PLAN AND ZONING COMMISSION MEETING

CITY OF DAVENPORT, IOWA

TUESDAY, OCTOBER 19, 2021; 5:00 PM

Case F21-11: Request of Origin Design on behalf of Russell Construction for a final plat of Russell-Frye/Armstrong Industrial Park 1st Addition for a 4-lot subdivision on 95 acres, located at 8730 Northwest Boulevard. [Ward 2]

FINAL PLAT

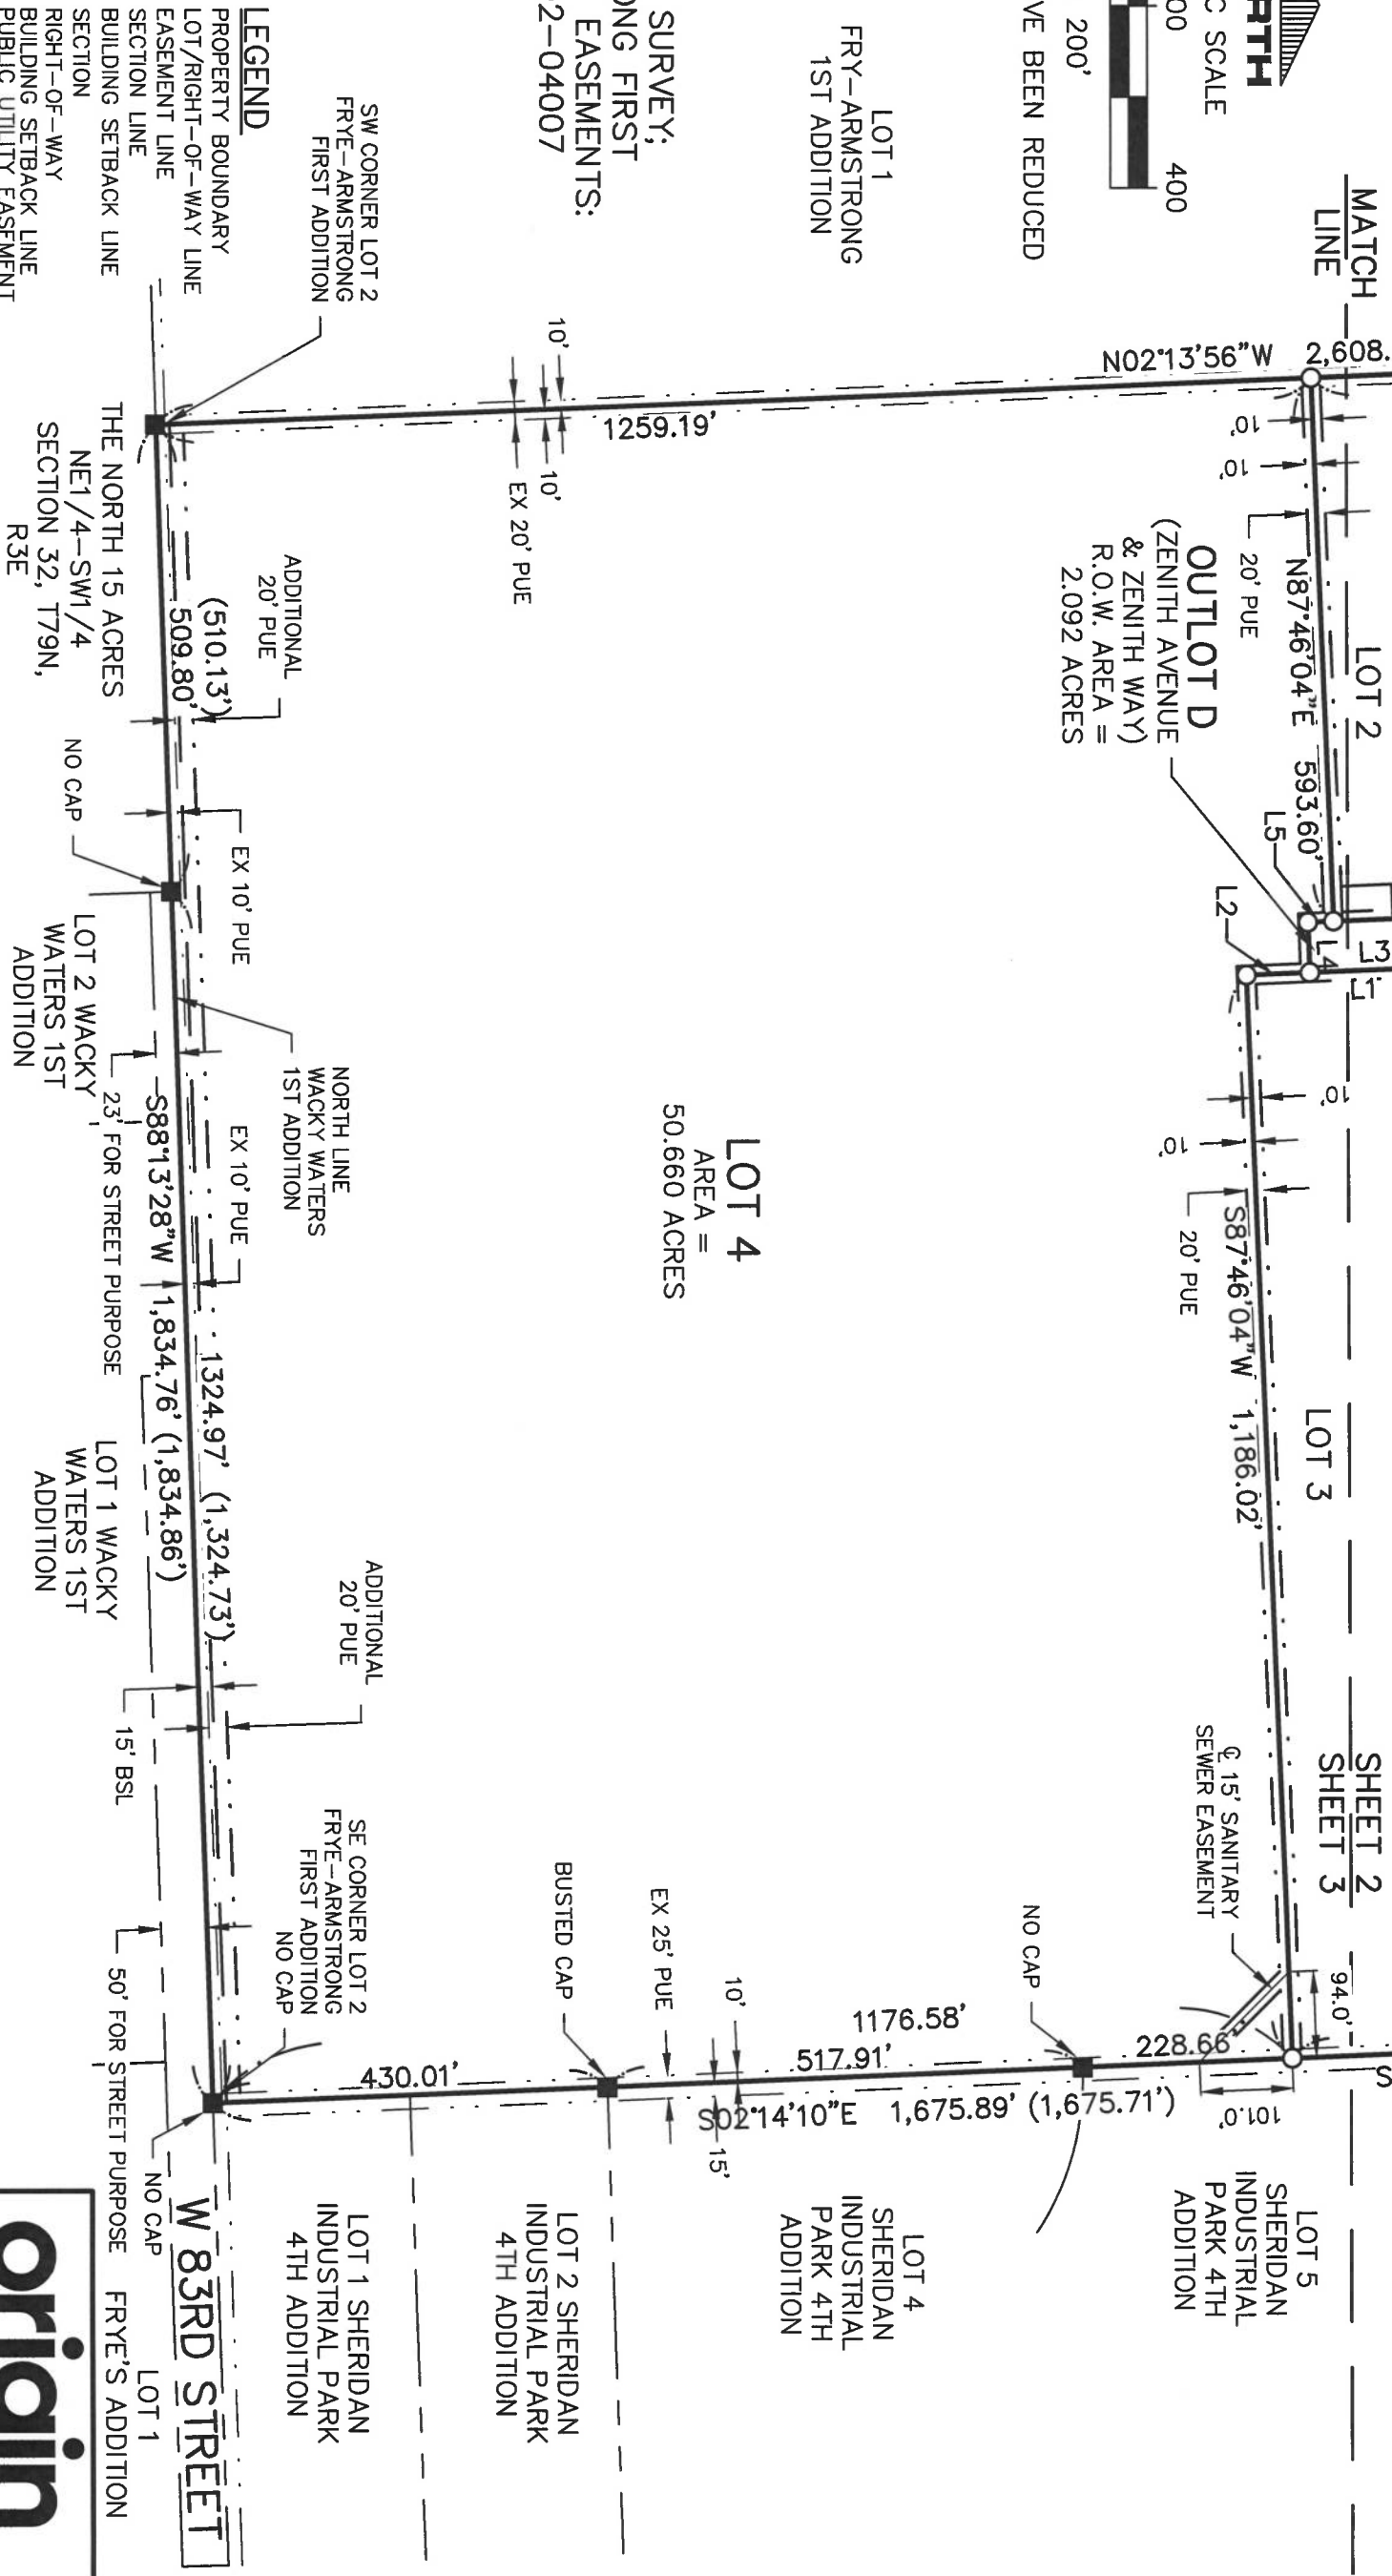
1. That the surveyor signs the plat.
2. That the utility providers sign the plat when their easement needs have been met.
3. Standard set of notes, including notes from the approved preliminary plat shall be added to the final plat.

4. Corporate limits shall be shown on the plat.
5. Public utility easements shall be a minimum of 15 feet or twice the depth of the utility line, whichever is greater.

6. Add a note stating, "Direct access from any lot onto Northwest Boulevard is prohibited."
7. Add the following note, "Access to West 90th Street shall be a minimum of 450 feet from the west right-of-way line of Northwest Boulevard."

8. All outlots shall have a description of purpose, the owner, and party responsible for maintenance on the final plat.
9. Add a note stating Zenith Avenue and Zenith Way shall be dedicated as public right-of-way on the plat. Remove the reference to "Outlot D".

10. Include a note regarding stormwater detention and water quality requirements that reads, "Stormwater detention and water quality treatment are required with this subdivision and will be subject to the applicable ordinances in place at the time of development."

11. Zenith Way shall be renamed to West 89th Street.
12. Add the directional to Zenith Avenue to read as "North Zenith Avenue".
13. Indicate the dedicated right-of-way width of Zenith Avenue.

14. Zenith Avenue requires an access easement for vehicle turnaround within Lot 3 and/or Lot 4.
15. Provide a drainage easement for stormwater runoff from the properties on the west side of the platted area. This easement must be capable of transferring the 100-year storm. Submit calculation to City staff.

PRELIMINARY PLAT BECKETT PLACE DAVENPORT, IOWA

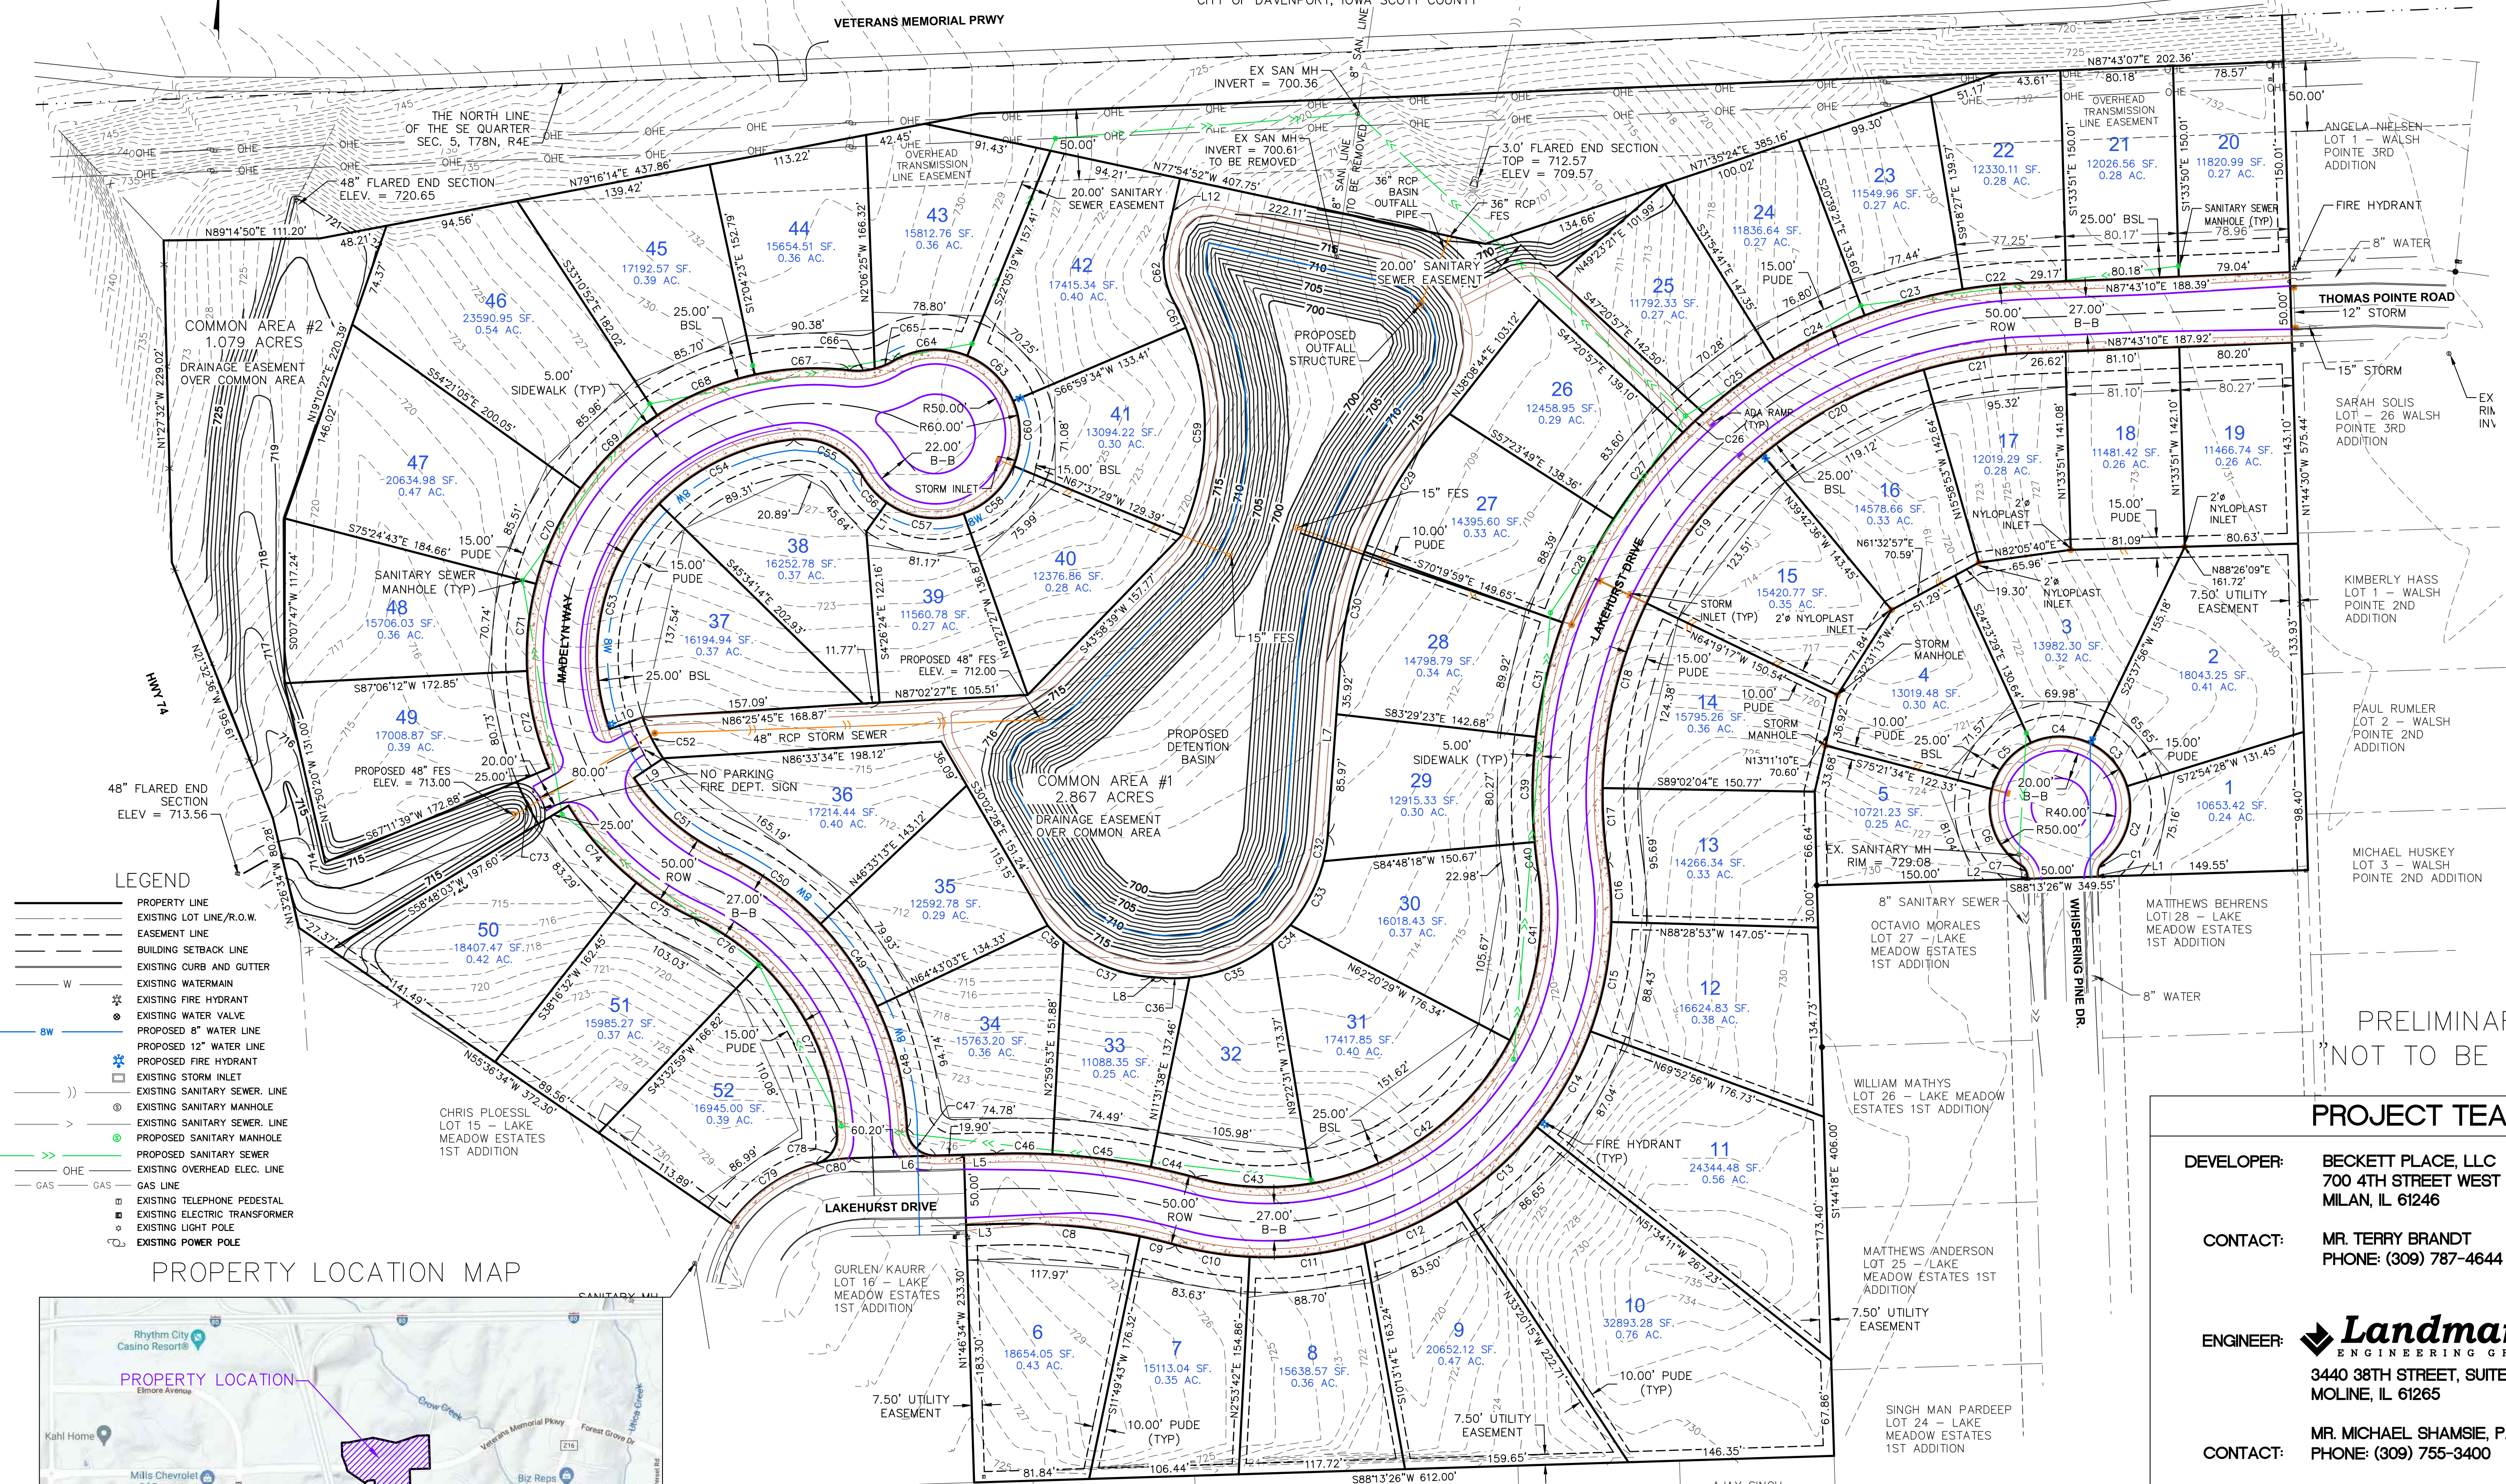
Staff supports a variance to exceed the maximum length of a cul-de-sac on Madelyn Way. However, the variance requests to exceed the maximum cul-de-sac length on Whispering Pine Drive and maximum block length on Thomas Pointe Drive, between Madelyn Way and Gabrielle Way, do not comply with the spirit and intent of the ordinance. The applicant may still subdivide the property in a reasonable manner without these two variances.

The R-2 Zoning District requires a front setback of 30 feet. The preliminary plat uses a setback of 25 feet. This will need to be corrected and reviewed to ensure all lots meeting zoning dimensional standards.

1. Streets: Whispering Pine Drive must connect to Thomas Pointe Drive. The block length between Madelyn Way and Gabrielle Way exceeds maximum allowed by code. Staff recommends denial of the variance requests. The standard specifications call for parking on only one side of the street where street width is 27 feet or less. Madelyn Way will need to be renamed to Madelyn Court and Lakehurst Drive must be renamed to Thomas Pointe Drive. Sidewalks are required along all city right-of-way. Due to the size of the unpaved surface within Madelyn Way, the land area should be within an outlot owned and maintained by the subdivision. The existing right-of-way on Lakehurst is 55 feet wide. A more gradual taper is required. The western corner of the front lot line of Lot 6 must align with Lot 16 of Lake Meadow Estates 1st Addition.

2. Storm Water: The site requires stormwater detention and shall meet water quality criteria in the Iowa Storm Water Management Manual. Storm detention is proposed in Common Areas 1 and 2, which should be relabeled as outlots. Access must be provided for maintenance of detention areas and any drainage ways must be maintained to provide for the proper flow of water. The full extent of the trail must be located within an access easement.

5. Other: This is an urban area and normal utility services are available. The public utility easement must be increased to 20 feet where water mains are planned. The fire department does not require the hammerhead turnaround midway through Madelyn Way.
